DOCKETED			
Docket Number:	24-BSTD-03		
Project Title:	2025 Energy Code Compliance Software, Manuals and Forms		
TN #:	267721		
Document Title:	Peak Cooling Metric Will Have Unintended Consequences		
Description:	Description: Early analysis using CBECC 2025 v2 indicate that compliance with the peak cooling metric for new single family projects will be difficult, even on typical mainstream projects. We suggest some remedies to improve the situation.		
Filer:	Nick		
Organization:	Build Smart Group		
Submitter Role:	Public		
Submission Date:	11/24/2025 12:39:33 PM		
Docketed Date:	11/24/2025

RE: Peak Cooling Metric

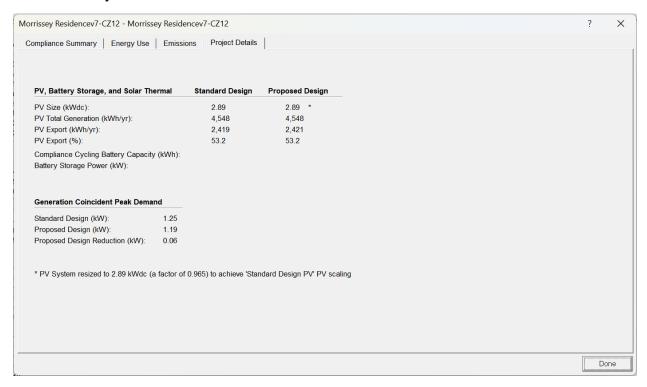
When we run this typical project, it passes on LSCe, LSCt, and Source, but fails peak cooling in every climate zone (4,8-15). This is not an unreasonable project design and

for it to fail in every applicable PC climate zone indicates that more challenging project designs are going to have serious trouble complying with the energy code.

Using Climate Zone 12 as an example, it uses 69 kWh too many for peak cooling to comply. Note that its generation coincident peak kW is actually below the standard design by 0.06 kW, but it fails peak cooling. This illustrates that the PC metric is not successfully identifying projects that will be a grid burden, but rather is doing something more arbitrary.

To get this project into compliance, the following feature upgrades were effective:

1) Whole house fan 5,170 cfm ECC verified, 0.14 W/cfm

## **Luxury Homes Fail Severely**

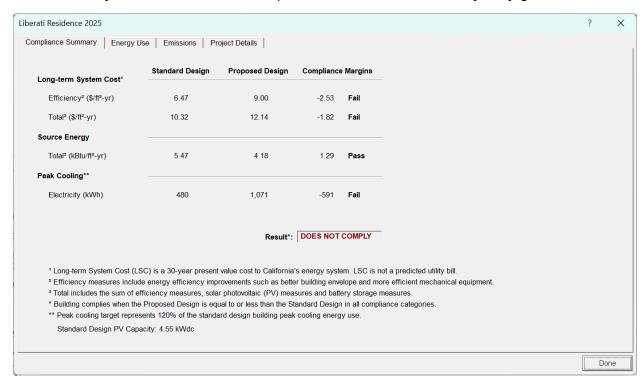
This firm regularly gets projects with 40% glazing or more for affluent homeowners with homes with views. When I ran one of these in CZ10 with the mandatory updates to window U factors and meeting cathedral ceiling prescriptive standards, this project is so far out of compliance on peak cooling that it may be impossible to get it to comply. Note that Efficiency LSC is also out of compliance, but HRV and battery may get that to work.
